Council Assessment Panel Minutes

16 May 2022

**2.1 DEVELOPMENT APPLICATION 21042128 – DESIGN INC ADELAIDE PTY LTD
- 84 PORTRUSH ROAD, 5 TARCOMA AVENUE, PAYNEHAM SOUTH**

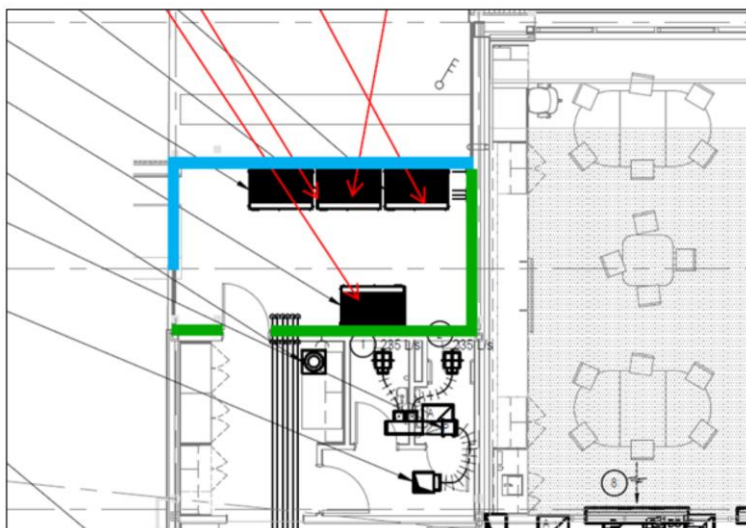
The application has been reviewed by Sonus acoustic engineers. Sonus have assessed the noise impacts of the mechanical plant associated with the proposed school building. Sonus have made the following recommendations to meet the goal noise levels.

- Construct a screen around the plant area, as shown in BLUE below, to a height of 2.2m. The screen should be sealed airtight at all junctions, including the ground, and may be constructed from a solid material (such as sheet steel), or acoustic louvres with acoustic performance equivalent to the Fantech SBL1 Louvres.

- Install acoustic absorption to the walls of the plant area for the extent shown in GREEN below. This should extend to the same height as the screen, being 2.2m. This absorption should be constructed as 50mm thick polyester insulation (with a minimum density of 32kg/m³) installed behind a perforated product such as timber or sheet steel in accordance with Figure 4. Alternatively, any proprietary product with an NRC of at least 0.6 may be used

2. A screen shall be constructed and maintained around the plant area, to a height of 2.2m. The screen should be sealed airtight at all junctions, including the ground, and may be constructed from a solid material (such as sheet steel), or acoustic louvres with acoustic performance equivalent to the Fantech SBL1 Louvres.

3. Acoustic absorption shall be installed to the walls of the plant area. This shall extend to the same height as the screen, being 2.2m. This absorption shall be constructed as 50mm thick polyester insulation (with a minimum density of 32kg/m³) installed behind a perforated product such as timber or sheet steel. Alternatively, any proprietary product with an NRC of at least 0.6 may be used.
